**NATMAC CONSULTATIVE LETTER**

**LONDON AIRSPACE MANAGEMENT PROGRAMME (LAMP) 1A POST IMPLEMENTATION  
REVIEW OF LOWER LIMITS OF CONTROLLED AIRSPACE**

**ATTACHMENT A TO  
NATMAC LETTER DATED  
13 OCTOBER 2016**

**Clacton CTA & Worthing CTA (East) Proposed Base Changes**

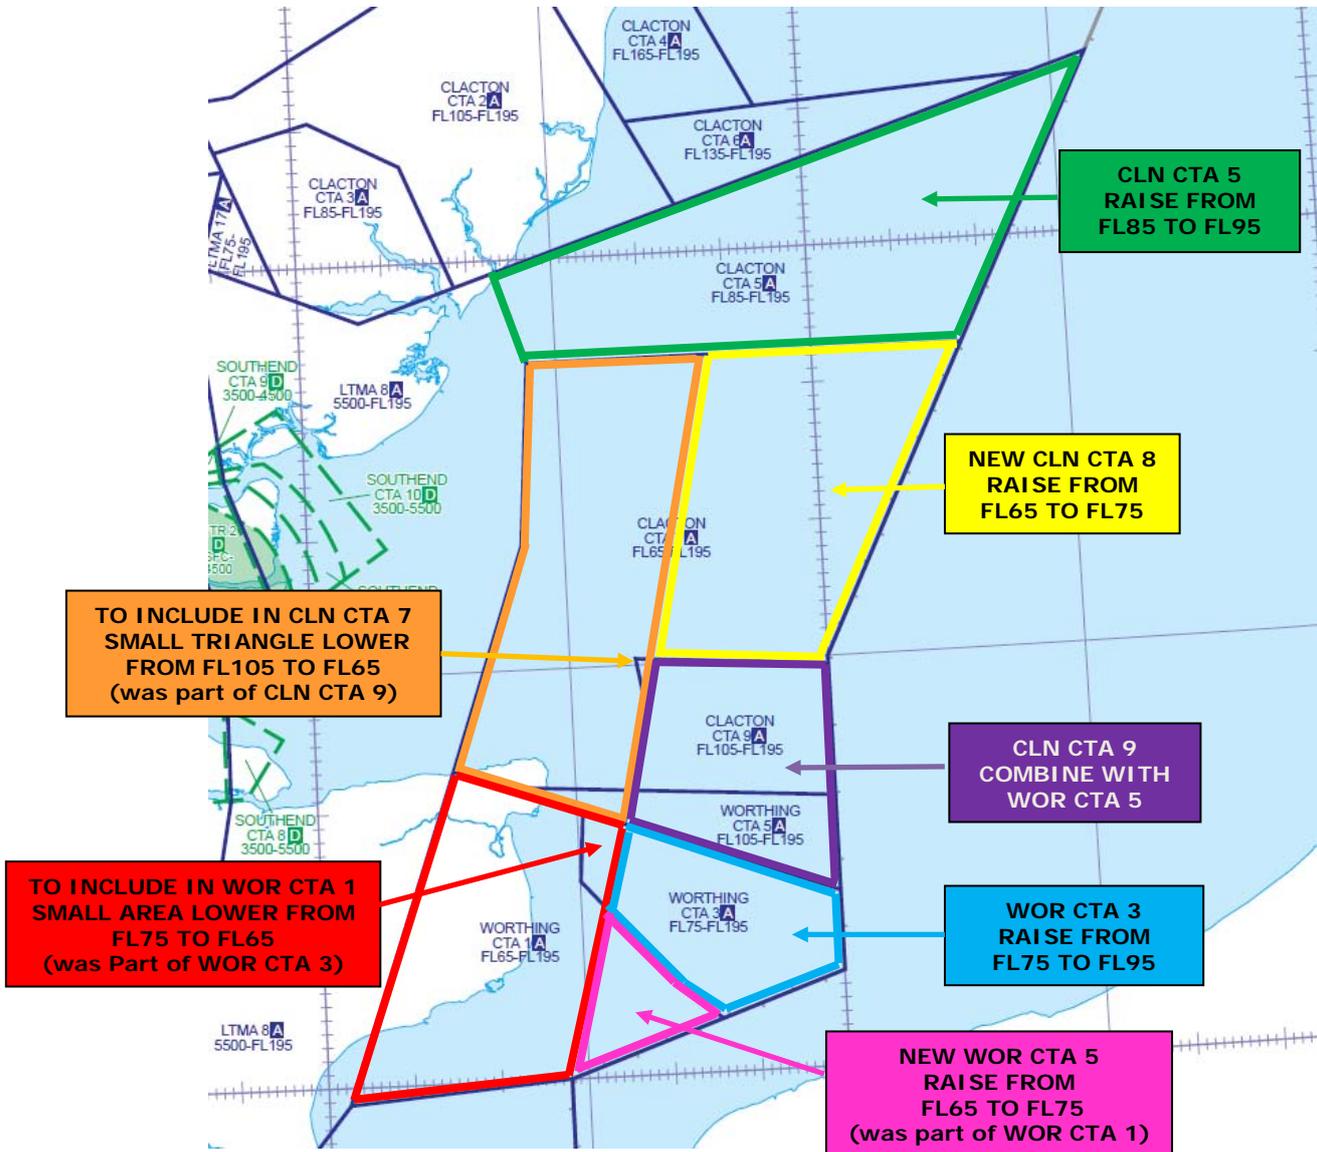
- Raise Clacton CTA 5 from FL 85 to FL 95.
- Raise eastern part of Clacton CTA 7 from FL 65 to FL 75 (would become Clacton CTA 8).
- Raise Worthing CTA 3 from FL 75 to FL 95.

- Raise eastern part of Worthing CTA 1 from FL 65 to FL 75 (would become new Worthing CTA 5).
- The CAA proposed that the Clacton CTA 9 could be combined with the existing Worthing CTA 5 thus enabling the Clacton and Worthing CTA boundaries to be re-defined as shown in Attachment A.

- The CAA proposed that a very small triangle of airspace at the northwest corner of existing Clacton CTA 9 be lowered from FL105 to FL65. This would then be subsumed into Clacton CTA 7, thus smoothing out the lateral limits.

- The CAA proposes that a small area of airspace at the northwest corner of existing Worthing CTA 3 be lowered from FL75 to FL65. This would then be subsumed into Worthing CTA 1, thus smoothing out the lateral limits.

# Worthing CTA (South) Option 1

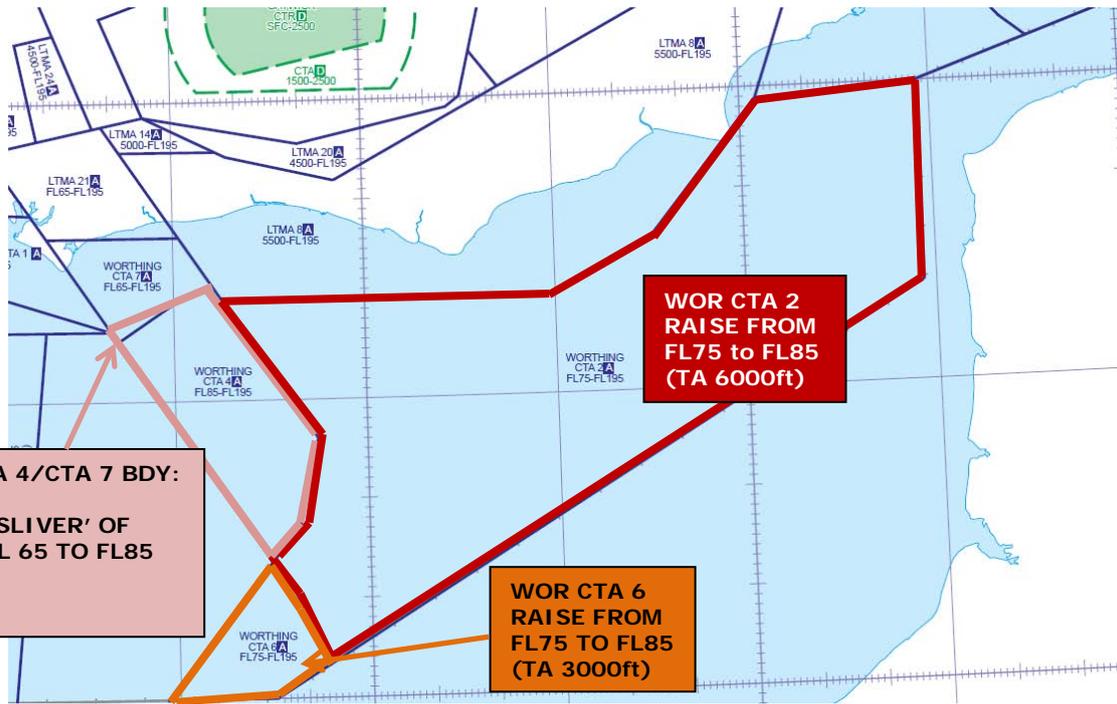
- Raise Worthing CTA 2 from FL 75 to FL 85.
- Raise Worthing CTA 6 from FL 75 to FL 85.
- Adjust the Worthing CTA 7 and CTA 4 common boundary to run in a straight line (almost east / west) from southeast corner of Portsmouth CTA 1 to northwest corner of Worthing CTA 2.

- Option 1 raises a small section of WOR CTA 7 on the west side.
- Option 2 raises a small section of WOR CTA 7 on the west side but lowers a small portion of WOR CTA 4 on the east side, however, the delineation of airspace boundaries is improved.
